CITY OF ALBUQUERQUE

RE: **St. Therese Catholic School**
311 Shropshire Pl. NW
Permanent C.O. - Denied
Engineer's Certification Date: 11/16/20
Engineer's Stamp Date: 6/17/19
Hydrology File: G14D092

HYDROLOGY REPORT NEW MULTI-PURPOSE BUILDING for ST THERESE CATHOLIC SCHOOL

C-100

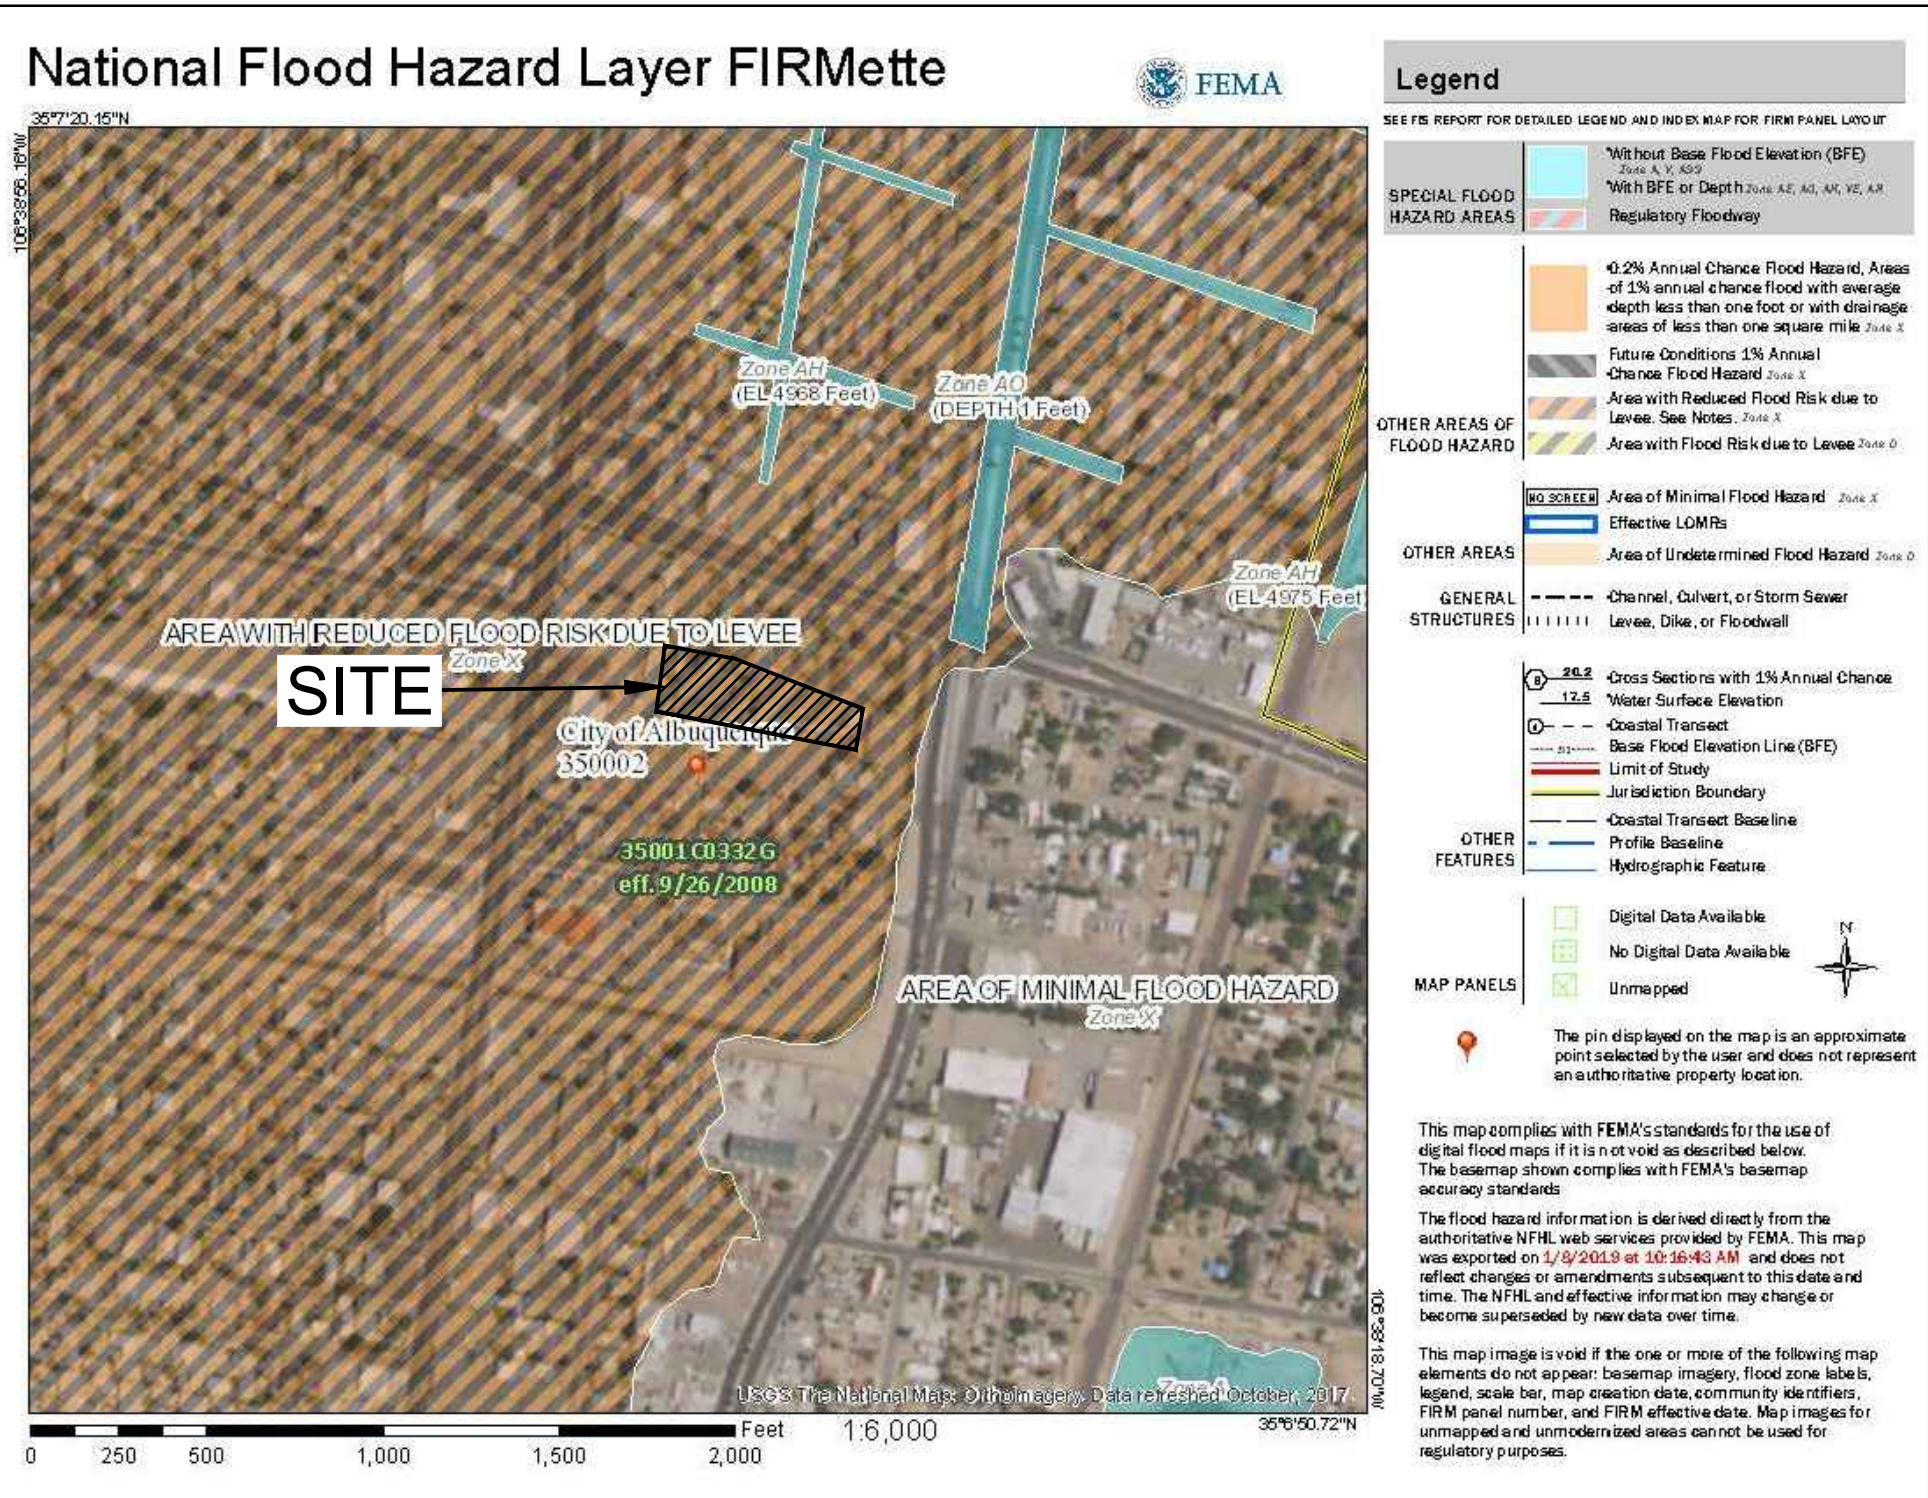
1. The Hydrology Report sheet C-100 you turned in with your submittal is not the approved plan. The sheet you have provided has made changes to the approved Storm Water Quality Volume (SWQV) calculations in an attempt to use the updated Development Process Manual (DPM). This plan was approved prior to the adoption of the revised DPM and is tied to the equations that were in place at that time.

2. Water Harvest Area 3 must be constructed or payment-in-lieu must be made for the remaining SWQV of 110 c.f. If you choose to utilize this option then Payment in Lieu (Amount = $110\text{CF} \times \$8/\text{CF} = \880 , per sheet C-100) of onsite management of the SWQV must be made. Take three copies of the treasury deposit slip to the Treasury and then include one copy of the paid deposit slip when resubmitting. Please let me know if you wish to use this option and I will generate an invoice for this amount.

3. When resubmitting please include and certify the approved plans from the Building Permit submittal. If you choose to utilize payment-in-lieu you may as-built the G&D.
